ATTACHMENT 7
PLAN REVIEW COMMENTS FOR COFA-02-26-020148

Town of Bluffton
Department of Growth Management
20 Bridge Street P.O. Box 386 Bluffton, South Carolina 29910
Telephone 843-706-4522
TOWNE CENTRE AT NEW RIVERSIDE

Plan Type:	Highway Corridor Overlay District	Apply Date:	02/26/2026
Plan Status:	Active	Plan Address:	2800 May River Xing Crossing BLUFFTON, SC 29910
Case Manager:	Angie Castrillon	Plan PIN #:	R610 036 000 3212 0000
Plan Description:	A request by Josie Abrams of Josie S. Abrams Architecture, on behalf of property owner Beaufort Memorial Hospital for review of a Certificate of Appropriateness - HCOD application. The project consists of the 5,000 S single story medical office building with associated infrastructure. The property is zoned Jones Estate Planned Unit Development (PUD) and consists of approximately 1.38 acres identified by tax map number R61 036 000 3212 0000 located within the May River Crossing Master Plan. STATUS: This item will be heard at the April 1, 2026 Development Review Committee Meeting.

BEAUFORT MEMORIAL MAY RIVER PRIMARY CARE

L500

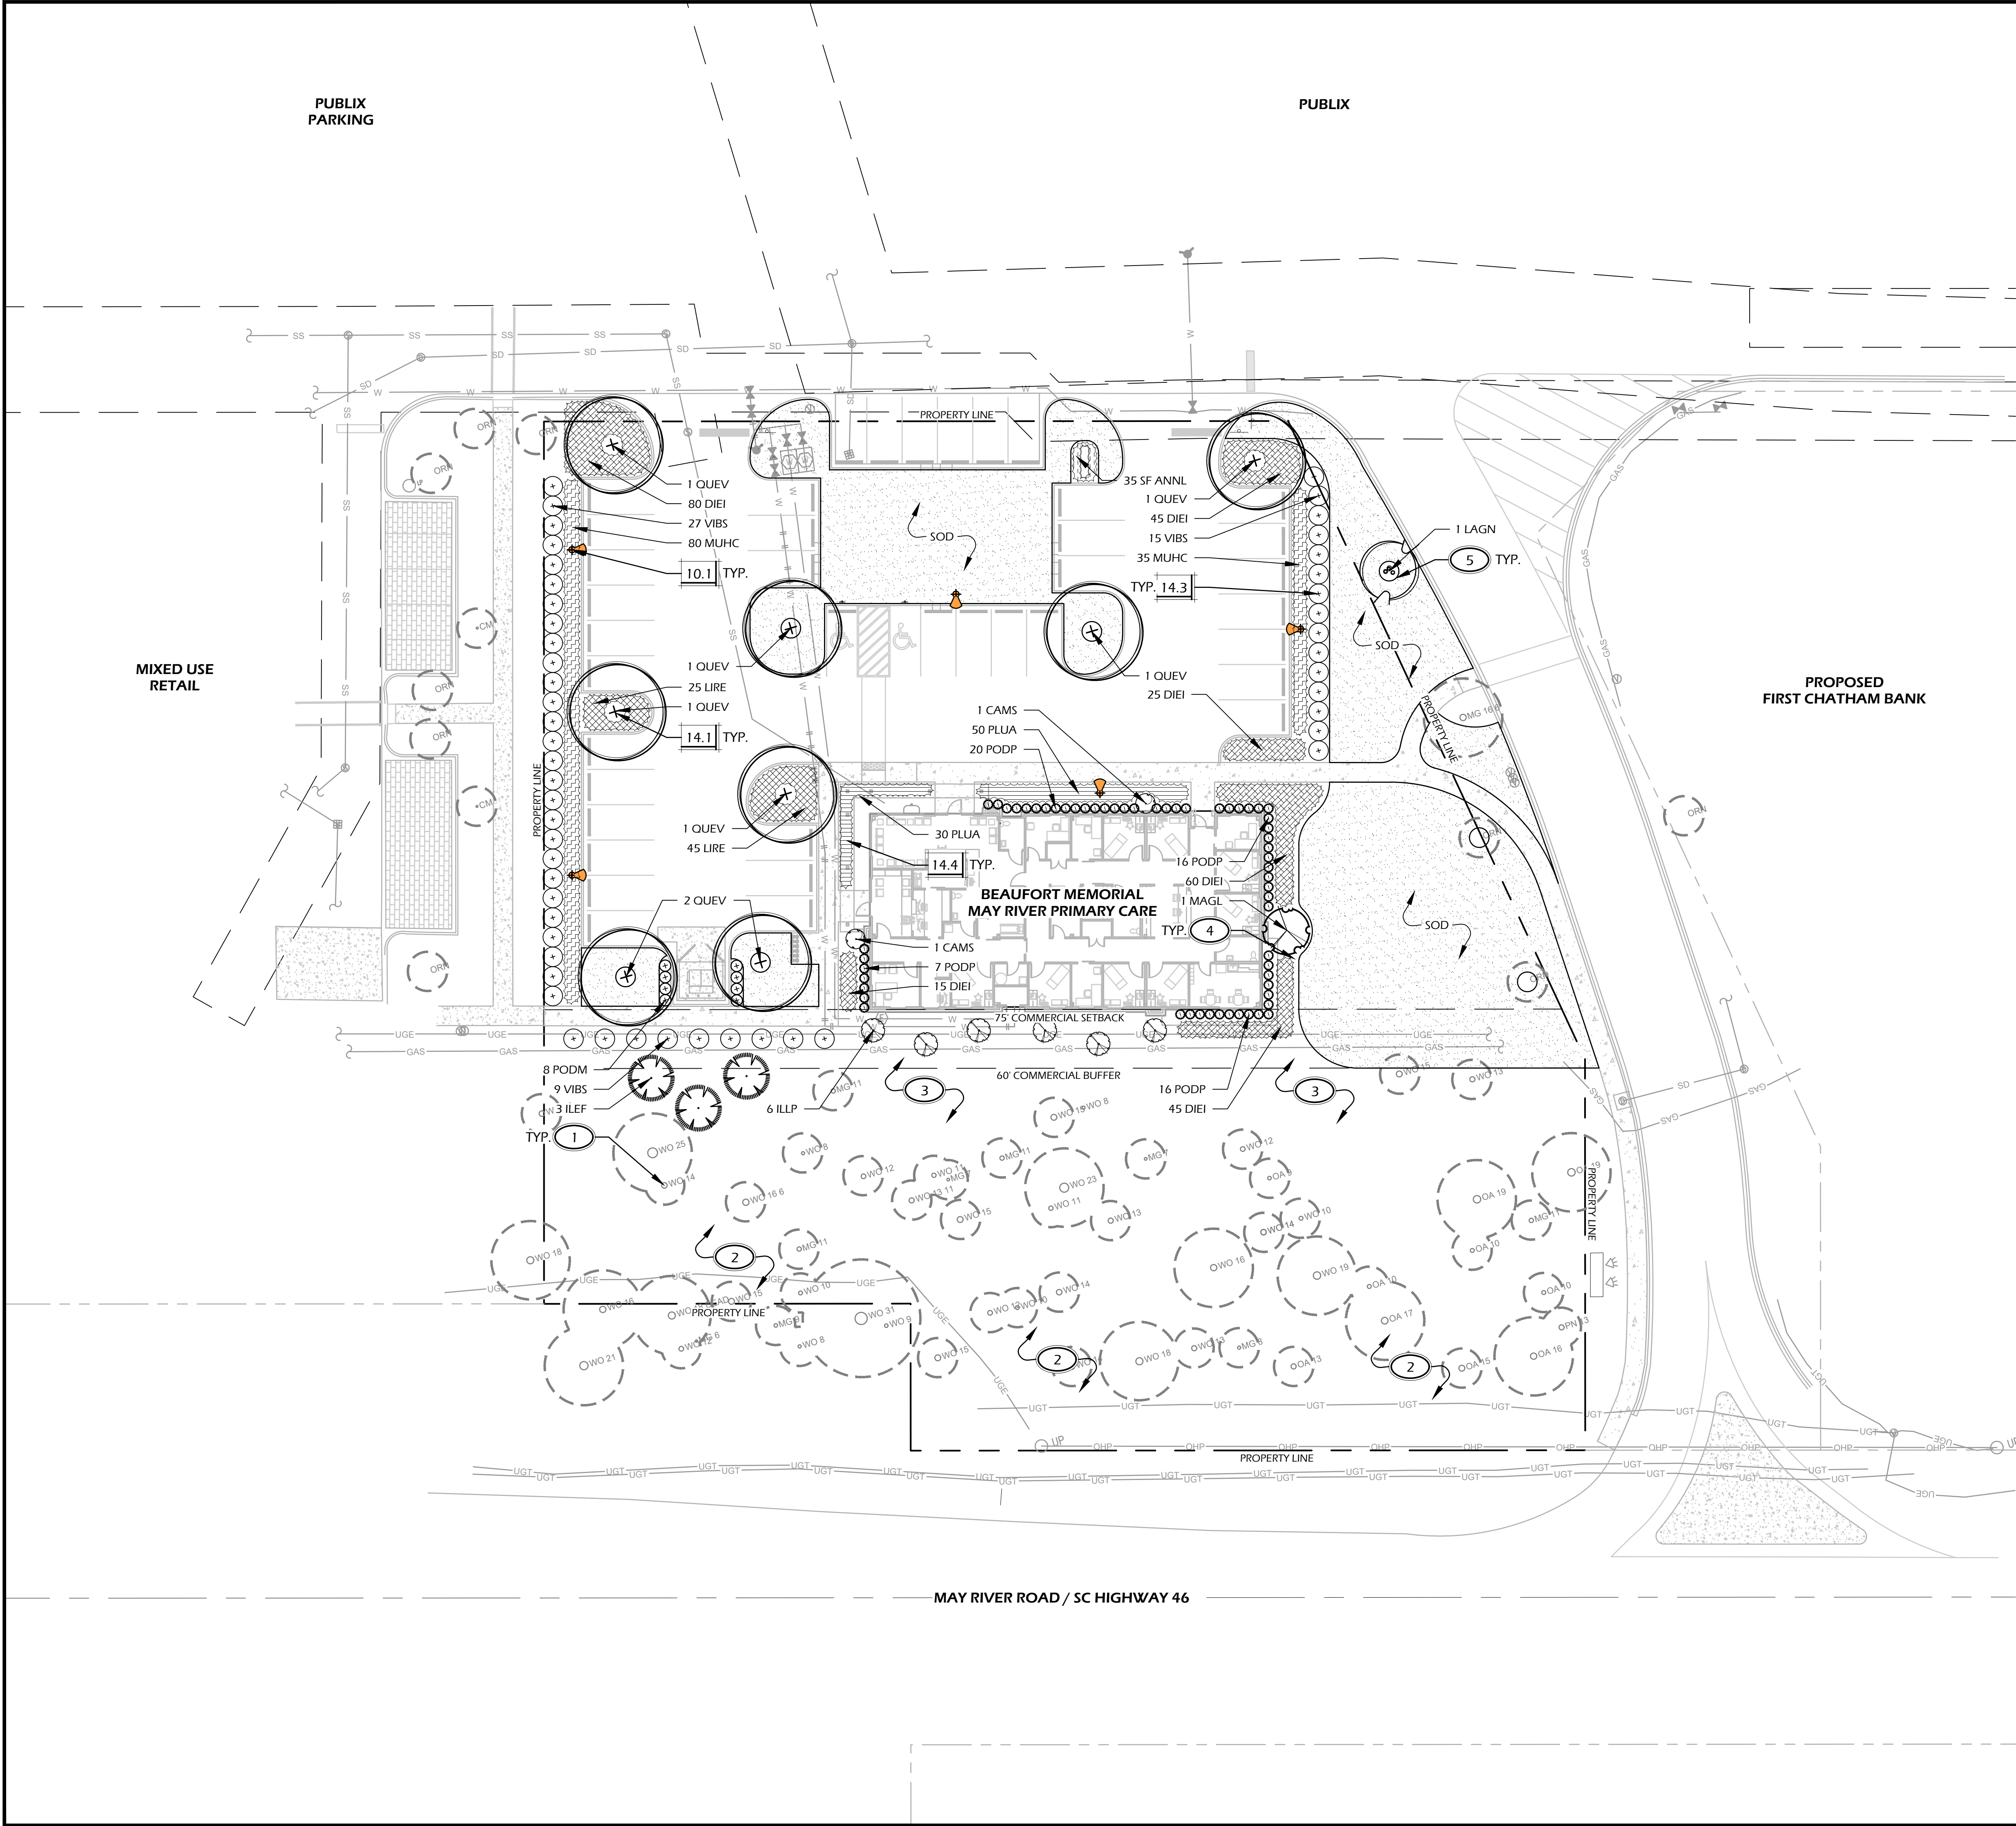
3. Confirm the suitability of proposed shrubs located over underground utilities south of the building.
4. Provide a letter of approval from the May River Crossing Master Plan Declarant responsible for the Covenants, Conditions and Restrictions.

A201

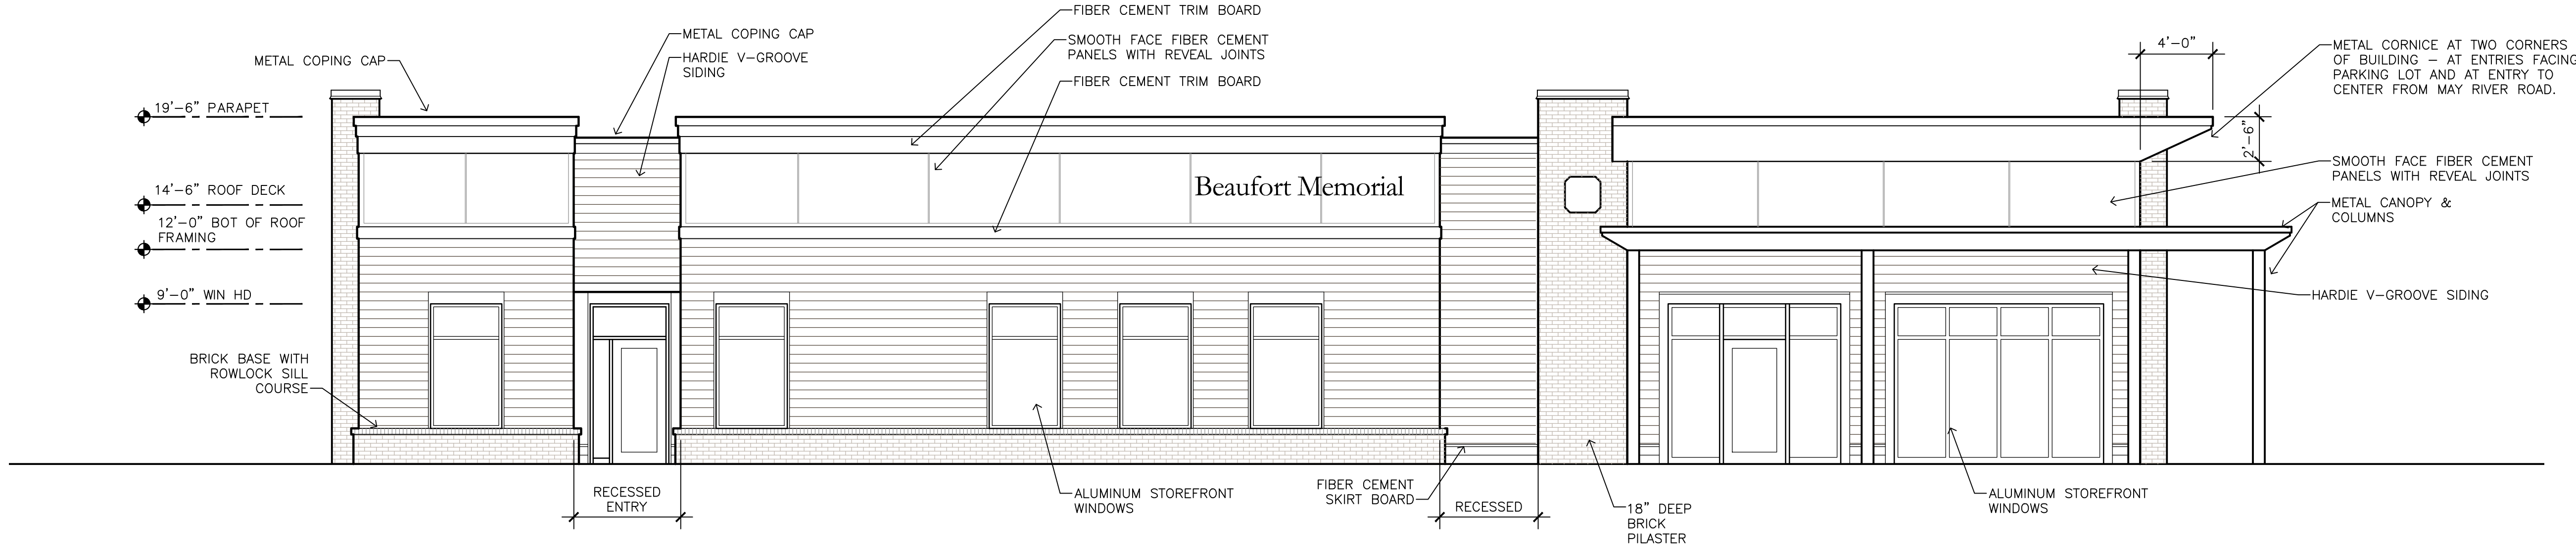
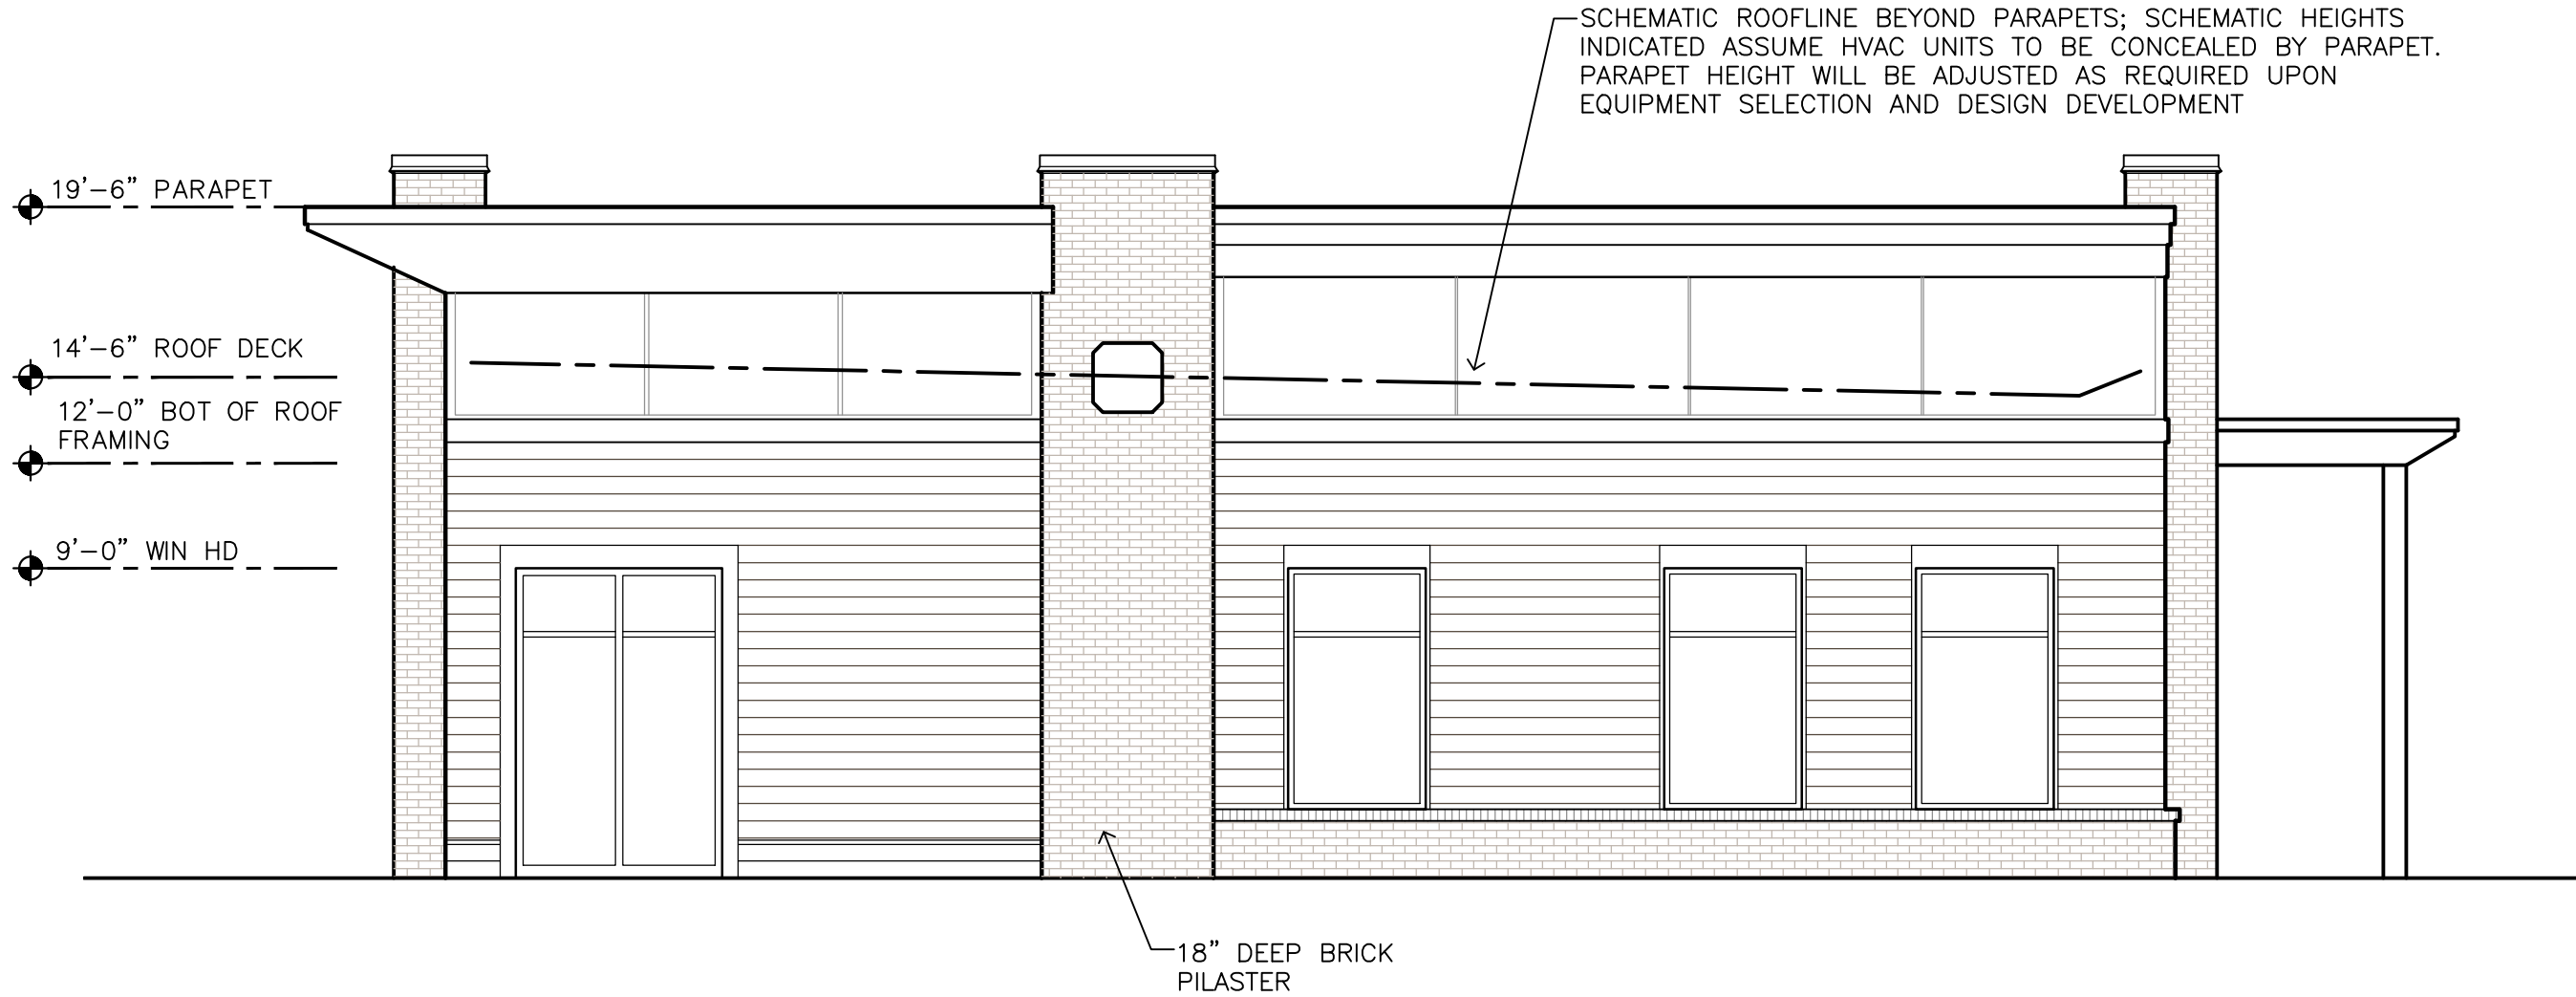
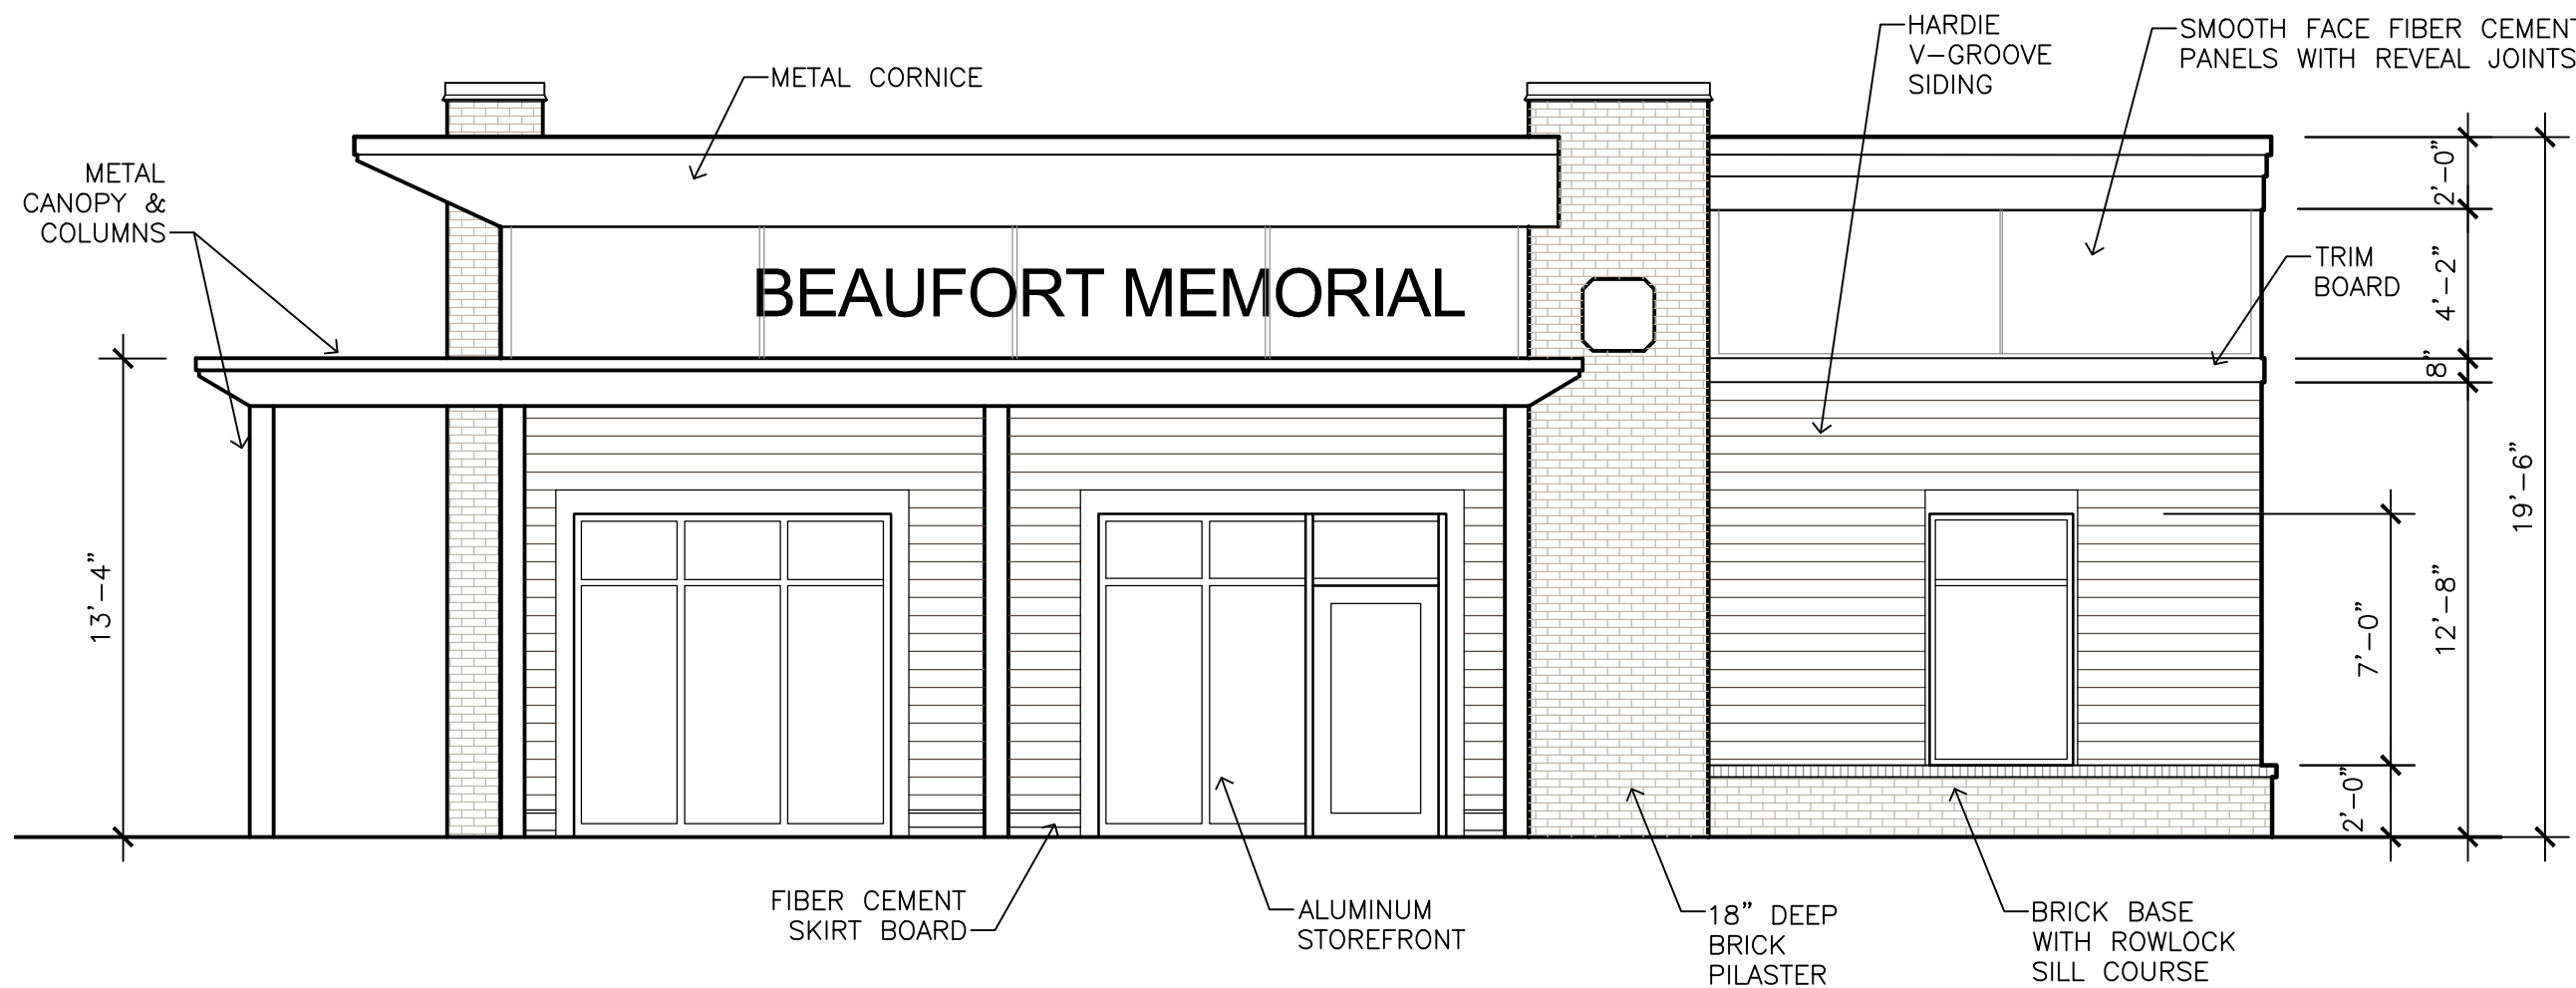
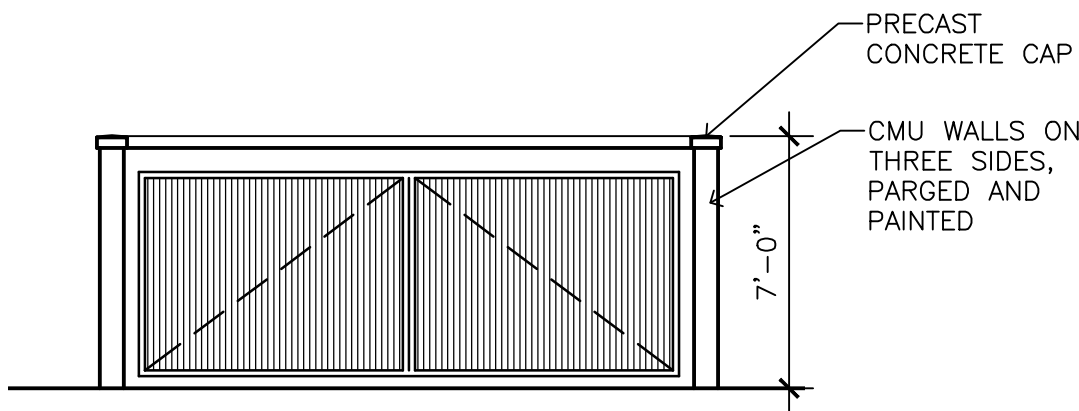
2. The Applicant has provided justification for the proposed roofline. Staff's interpretation remains that the ordinance (ZDSO 90/3) intends to discourage unarticulated flat rooflines. Based on that interpretation, and the supporting architectural narrative, the proposed cornice is viewed by Staff as meeting the guideline requiring a pediment.
